Access Compliance Report Public Rights-of-Way (Curb Ramps)

Intersection ID: 47227 Main Street: VALLEYDALE RD **Cross Street: OAKSHIRE CR** Location: Ε ADA ID: 18306FC915F8 Ramp Type: PerpDiag Initial Pass/Fail: Fail **Overall Compliance: No Severity Score:** 25

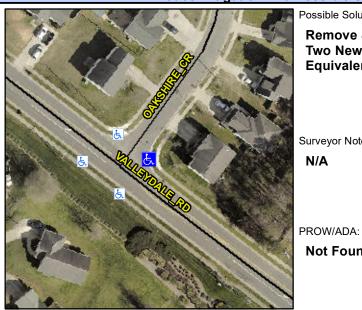
Not Found, R304.5.3

Field Measurements/Component Compliance						
Compliance Description		Data	Compl	liance	Description	Data
N/A	Ramp Length (in)	51.0	Yes	Ramp	Slope (%)	5.2
Yes	Ramp Width (in)	55.0	No	Ramp	XSlope (%)	7.5
N/A	Flare Type LT	N/A	N/A	Flare	Гуре RT	N/A
N/A	Flare Slope LT (%)	N/A	N/A	Flare	Slope RT (%)	N/A
N/A	Flare Traversable LT?	N/A	N/A	Flare	Traversable RT?	N/A
N/A	Landing Length (in)	N/A	N/A	DWS	Provided?	N/A
N/A	Landing Width (in)	N/A	N/A	DWS	Contrast?	N/A
N/A	Landing Slope (%)	N/A	N/A	DWS	Length (in)	N/A
N/A	Landing X Slope (%)	N/A	N/A	DWS	Full Width?	N/A
N/A	Landing Curb? (Y/N)	N/A	N/A	DWS	Offset (in)	N/A
N/A	Shared Landing?	N/A				
N/A	Gutter Ponding?	N/A	N/A	Gutter	Slope (%)	N/A
N/A	Gutter Lip Ht (in)	N/A	N/A	Gutter	X Slope (%)	N/A
N/A	Painted X Walk1?	No	N/A	Painte	d X Walk2?	No
	X Walk 1 Direction	To NW		X Wall	k 2 Direction	To SW
N/A	X Walk 1 Width (in)	N/A	N/A	X Wall	k 2 Width (in)	N/A
	X Walk 1 Slope (%)	0.3		X Wall	k 2 Slope (%)	5.5

Possible Solutions: Remove & Replace Curb Ramp With Two New Directional Ramps or Equivalent. Surveyor Notes:
